PARTS & SERVICE NEWS

REF NO. AA00084

SUBJECT: RELEASE NEW MEANS OF MOUNTING ENGINE WIRING HARNESS

APPLICATION: WA500-3LE Wheel Loader Serial Number A70001 through A70174

Engine Line Electrical System

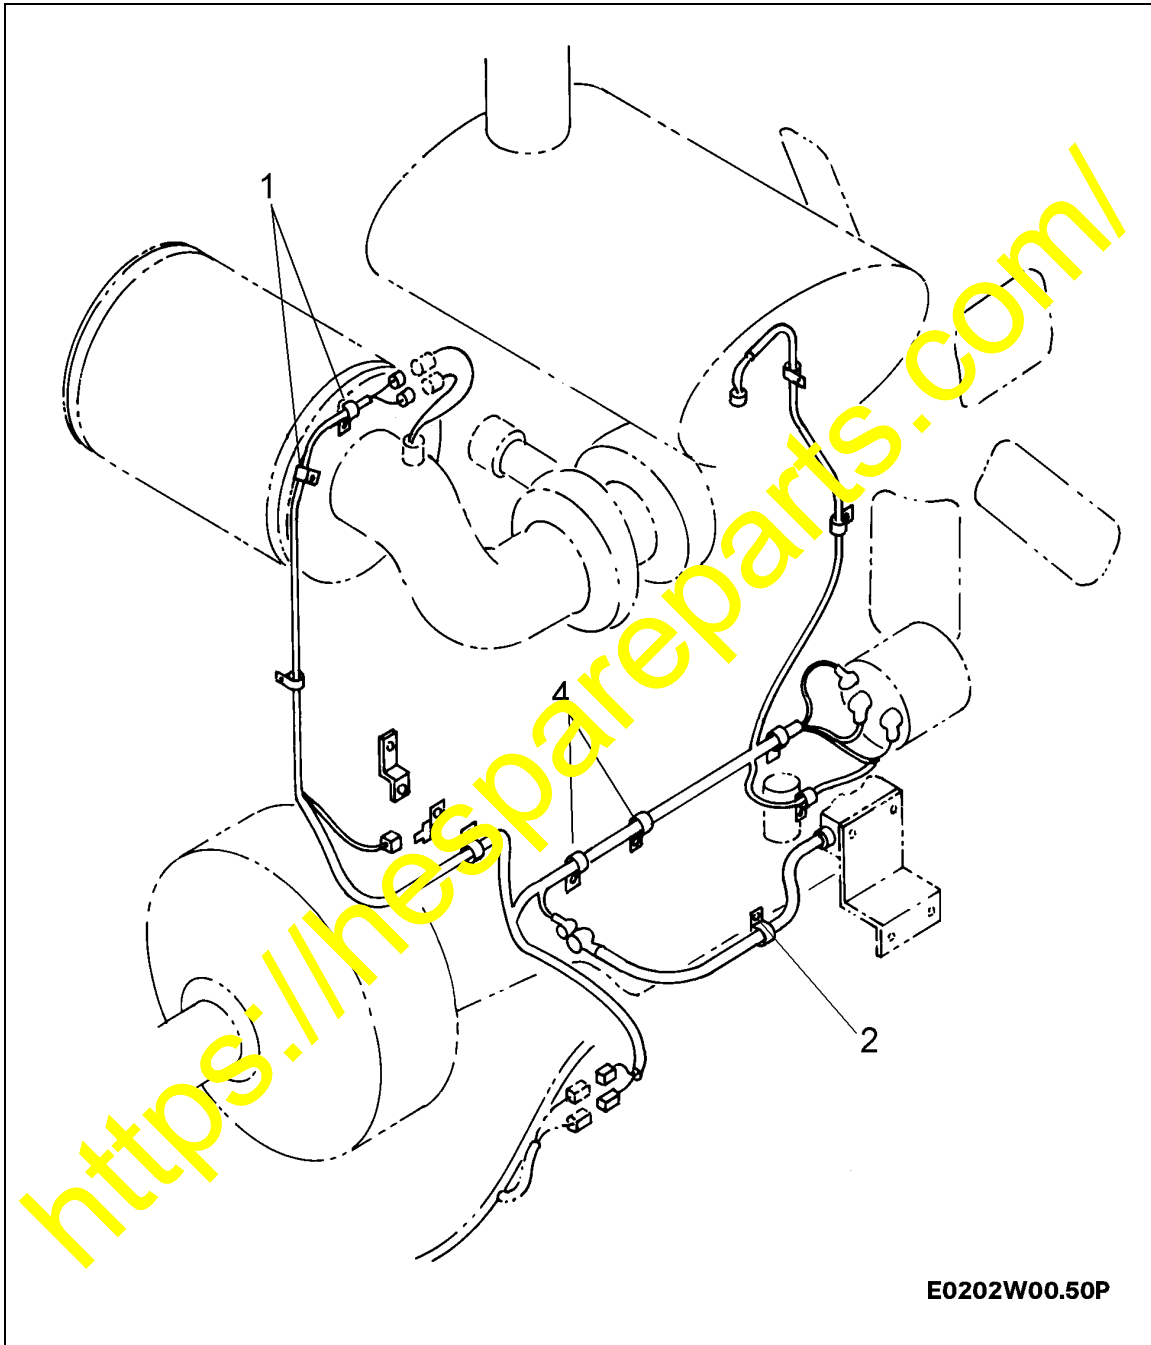
PURPOSE: Cost reduction and correction of drawing and BOM errors

1. Band tie (Item 1) the harness to the aspirator tube.
2. Position of clippings (Item 4) changed to stud bolt location.
3. Change nut size from 1/4" to 5/16" (Item 2) and add 1 washer (Item 3) per location.
